TECHNICAL SERVICE INFORMATION BULLETIN

TSIB 16-01 rev A

TO:	All Operators
TITLE:	Rework existing exhaust tube support bracket for updated Cummins EGR cooler installation
APPLICABILITY:	All New Flyer Diesel Low Floor Buses built before Sept 2010 with engines meeting the 2007 or 2010 EPA emissions certification

Figure 1

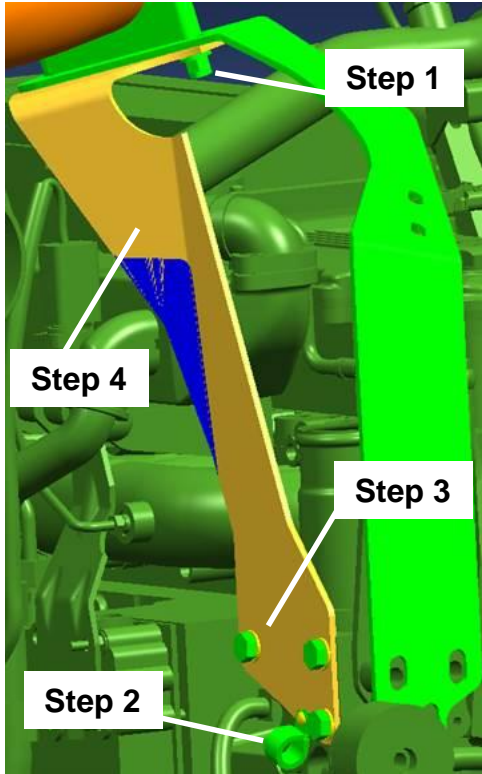
1. Remove and save the existing U-bolt hardware. See Figure 1 on page 2.
2. Remove and save any hose and/or cable support p-clips and mounting hardware. Tie back any loose hose and/or cables that may interfere with the bracket removal. See Figure 1 on page 2.
3. Remove and save the existing bracket mounting hardware. See Figure 1 on page 2.
4. Bracket must be removed to be reworked. Using a band saw or die grinder rework the existing bracket by removing the area, as shown in Figure 2 on page 2. Using a zinc rich primer, prime any bare metal left from the removal process before reinstallation to prevent corrosion.
5. Install reworked bracket using existing hardware, removed in Step 3. See Figure 3 on page 2. Torque hardware to 35 ft-lb.
6. Install the U-bolt hardware, removed in Step 1.
7. Re-install the hose and/or cable support p-clips and mounting hardware, removed in Step 2.

Figure 2

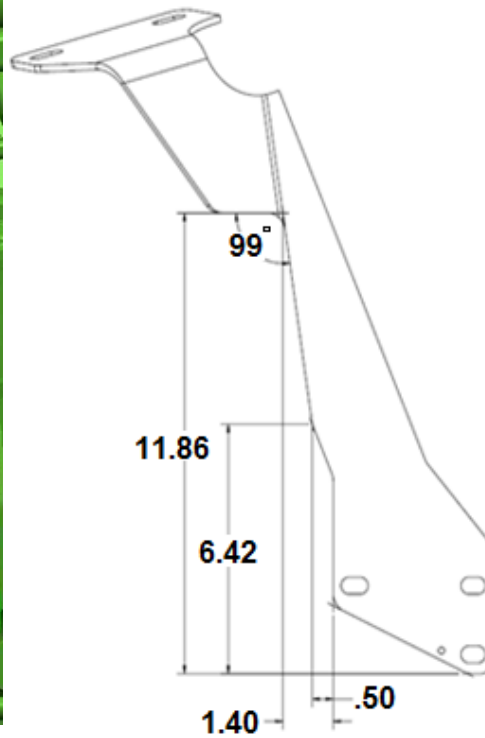
P/N 315247 Modified

When replacing the original EGR cooler with a new Cummins EGR cooler (Cummins PN 5343328) the exhaust support bracket (NF PN 315247) will need to be reworked, as per the following instructions, to fit properly. As an alternative to the rework of the existing bracket, you may order a new revised bracket (NF PN 315247 Revision G) as a direct replacement.

Figure 3

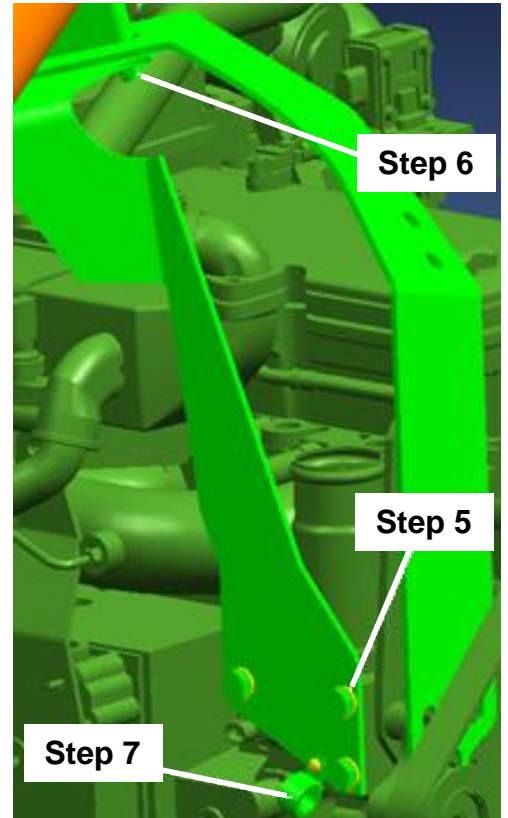
Reworked Bracket
